Details of site fencing, gates and railings, hard surfaces and acoustic fencing for the development on Site 2 pursuant to planning permission TW/10/4051 for the redevelopment of The Skinners Kent Academy, Blackhurst Lane, Tunbridge Wells – TW/10/4051/R16&R23

A report by Head of Planning Applications Group to Planning Applications Committee on 14 February 2012.

Details of fencing, gates and railings, hard surfaces and acoustic fencing for Site 2 as part of the redevelopment of The Skinners Kent Academy, Tunbridge Wells – TW/10/4051/R16&R23

Site 2 Acoustic Fence Details

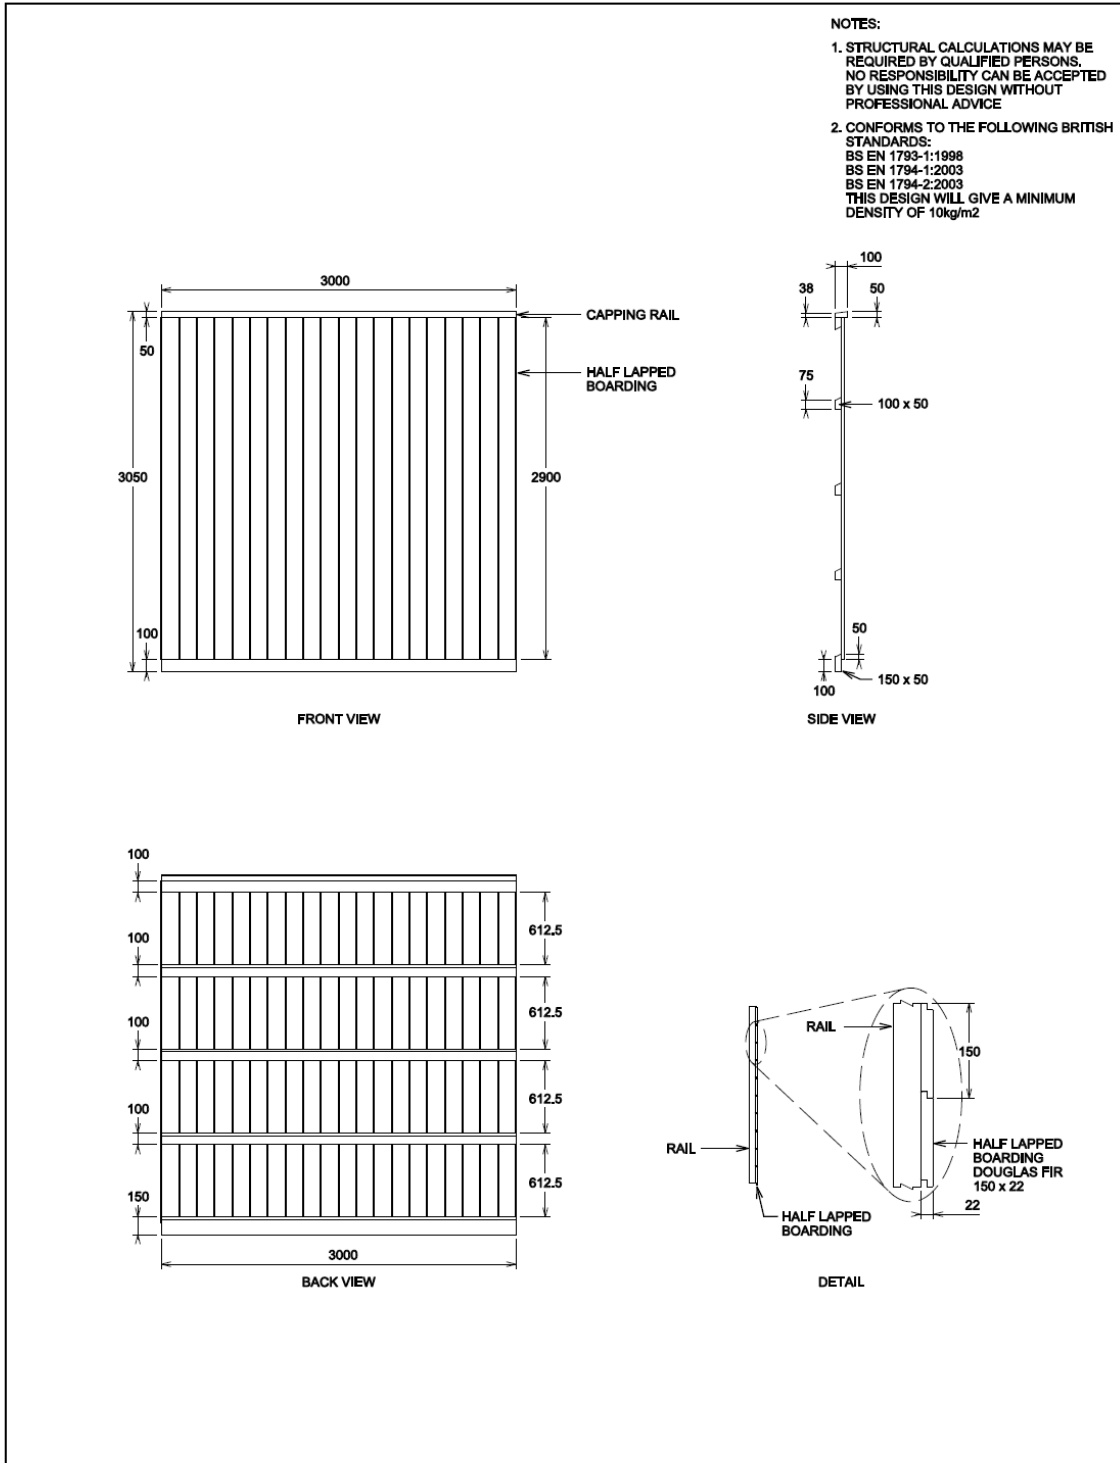
The 3 metre noise barrier constructed of half lapped timber panels as detailed in Hales Sawmills drawing (Drawing no. HSM 102) and the acoustic test report from the University of Salford, would provide the anticipated barrier performance and that noise levels would remain as detailed in the original noise report (PC-10-01-0168-RP1 Revision C).

- the 'acoustic' fencing is a token measure, the fence proposed is simply a tall wooden fence and is not proper noise absorptive acoustic fencing;
- why is the same acoustic fencing being proposed for Site 2 as has been installed surrounding the MUGA's on Site 1 – notes that noise complaints have been received from a local resident following the first usage of the MUGA's on Site 1;

- lack of adequate noise protection for residents on the Sandown Park side of Site 2;
- concerned that users of Site 2 will create harmful noise by kicking balls directly against the acoustic fencing for training purposes – why is there no welded-mesh fence on the inside of the acoustic fence as there is surrounding the AWP;

29. The positions of the acoustic fence were broadly established at the time of the original planning application. The acoustic fencing proposed comprises of a substantial construction of 3 metre high timber half-lapped fencing with a preservative applied with a natural finish. The details provided relating to the acoustic fence state that it would achieve a minimum density of 10kg/sq. metre. The specification of this acoustic fence is the same as that which has been recently installed on Site 1 around the new MUGA's, the technical specification of which was approved by the County Planning Authority in July 2011. The specification of the acoustic fencing proposed is considered to be acceptable by the County Council's Noise Consultant (see paragraph 18) where he concludes the overall height and density to be appropriate. Noise modelling plots have been produced by the applicant to demonstrate the noise reduction benefits of the acoustic fence on surrounding residential properties, a benefit which was fully considered at the time of the original planning application decision was taken.

30. Whilst I note that concerns have been raised regarding the overall height and positioning of the acoustic fence, I am satisfied that the locations where it is intended to be installed (as outlined in paragraph 14 above) are the most appropriate locations in this instance. The height of the fence at 3 metres was broadly agreed at the original planning application stage, with noise calculations submitted at that time demonstrating the acoustic benefits associated with the fence based on modelling undertaken with a 3 metre high fence. To consider a reduced height of acoustic fencing would reduce the effectiveness of the fence to deliver an overall noise reduction from Site 2 activities for adjoining residential occupiers.
